**POST BID ADDENDUM NO. 03
LEGRANDE ELEMENTARY SCHOOL ADDITION AND RENOVATION
SCB PROJECT NO. 2210**

FROM: Sherman Carter Barnhart Architects
144 Turner Commons Drive, Suite 110
Lexington, Kentucky 40508

DATE: September 11, 2023

This Addendum consists of 50 pages / drawings.

1 FIRST FLOOR PLAN - PLUMBING DEMOLITION
SCALE: 1/8" = 1'-0"

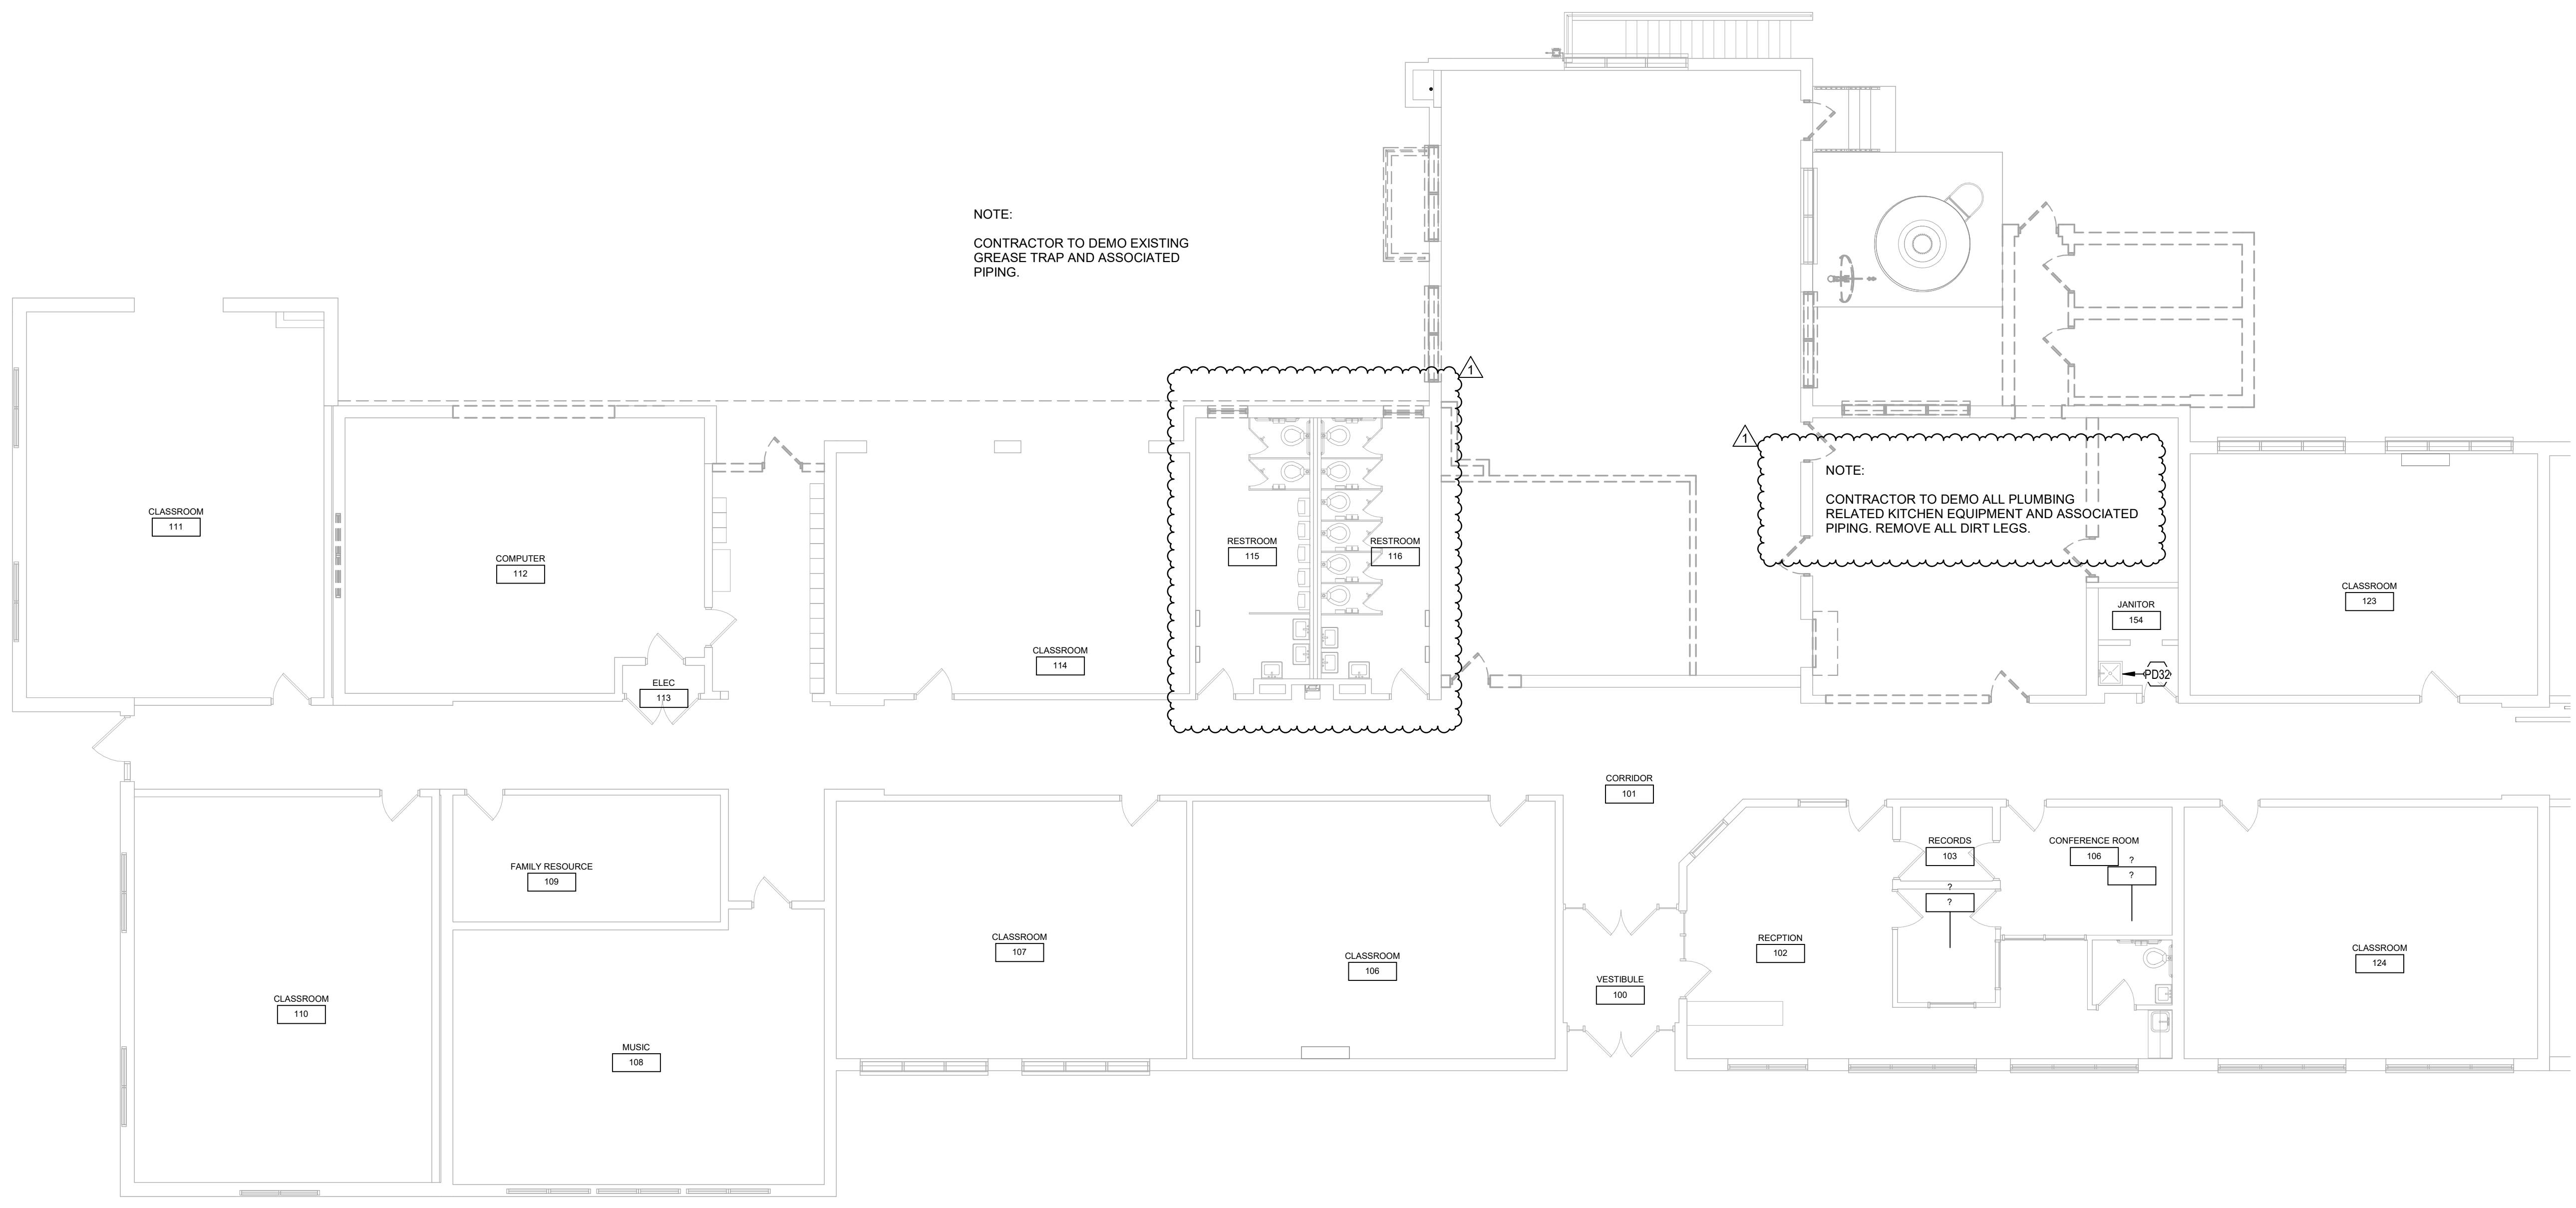
- a. Omitted restroom 115/116 plumbing demolition.
Add or Deduct: \$_____.
3. Sheet P1.2 – FIRST FLOOR PLAN - PLUMBING DEMOLITION
 - a. Omitted restroom 115/116 plumbing demolition.
Add or Deduct: \$_____.

1 FIRST FLOOR PLAN - PLUMBING
SCALE: 1/8" = 1'-0"

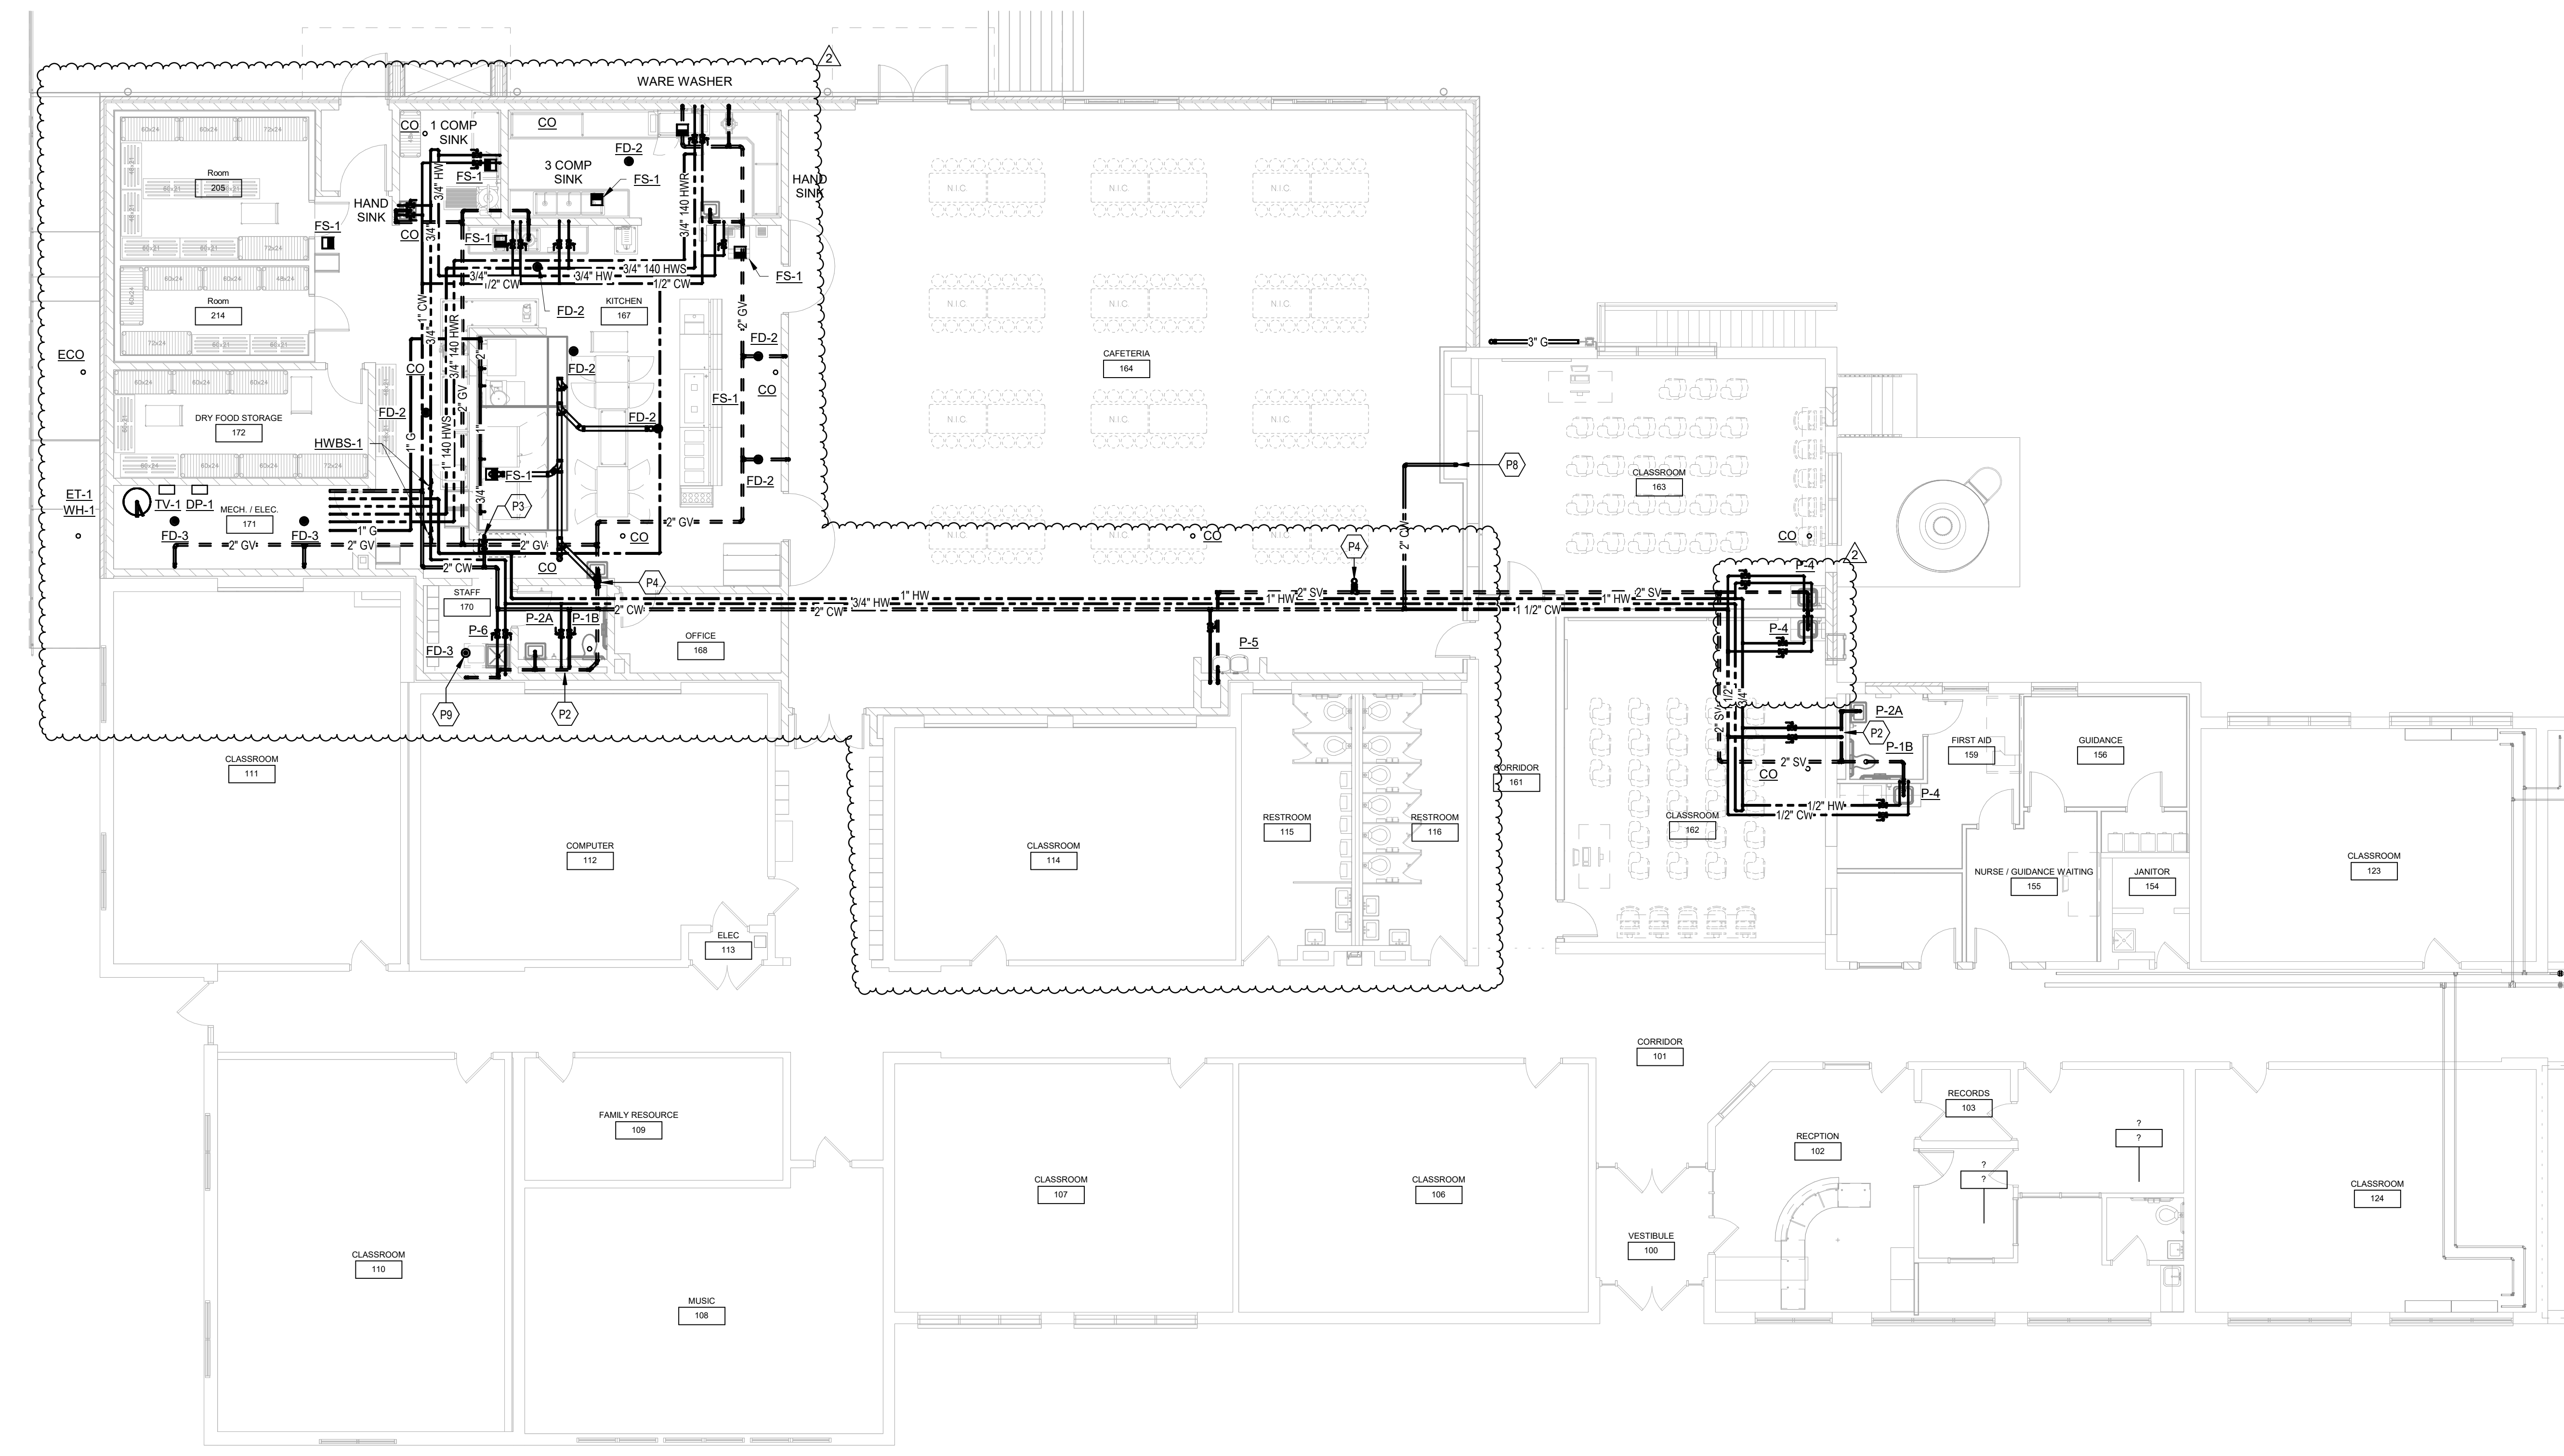
- c. Added back to back sanitary for new sink location.
Add or Deduct: \$_____.
5. Sheet P2.2 – FIRST FLOOR PLAN – PLUMBING
 - a. Omitted restroom 115/116 plumbing new work.
Add or Deduct: \$_____.

- b. Added Natural gas line for water heaters, refer to water heater detail on sheet P1.0.
Add or Deduct: \$_____.
 - c. Added back-to-back sanitary for new sink location.
Add or Deduct: \$_____.

1 ENLARGED BASEMENT PLAN - PLUMBING
SCALE: 1/4" = 1'-0"

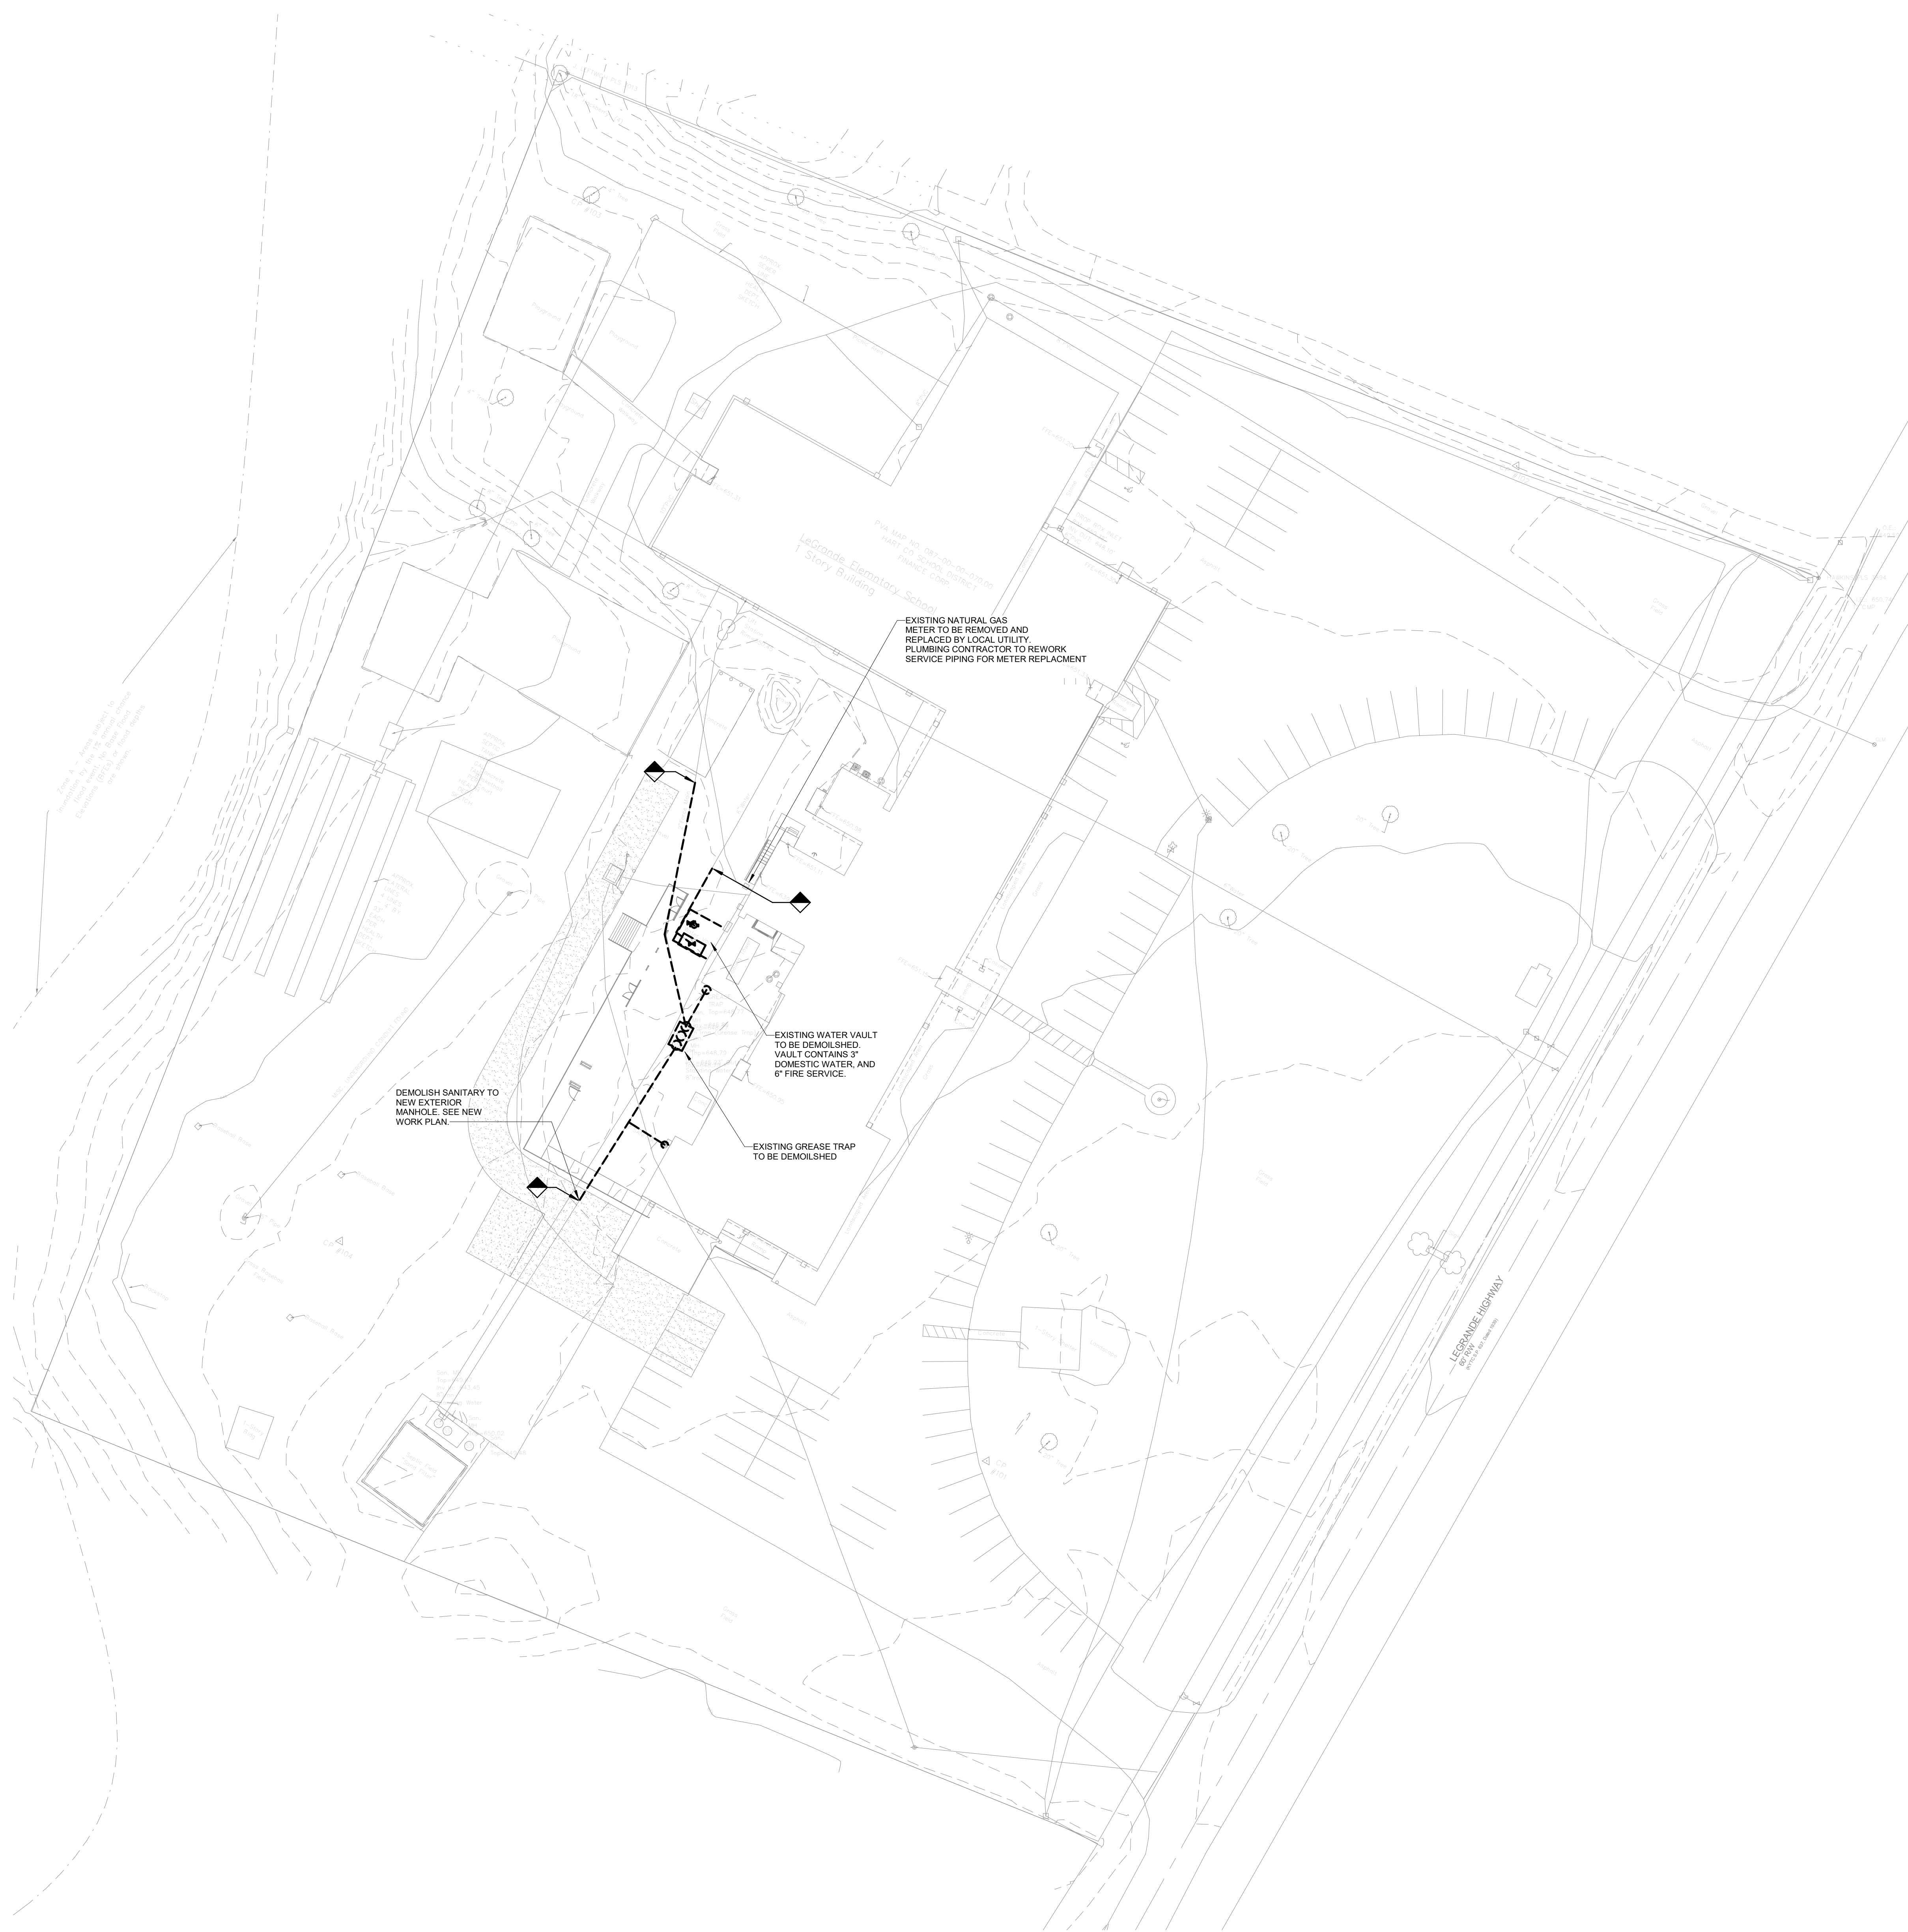
6. Sheet P3.1 – ENLARGED MECHANICAL ROOM PLAN – PLUMBING
 - a. Added existing domestic water scope and back flow preventer.
Add or Deduct: \$_____.
 - b. Added new 3" domestic water line out to site.
Add or Deduct: \$_____.
 - c. Added back-to-back domestic water for new sink location.
Add or Deduct: \$_____.
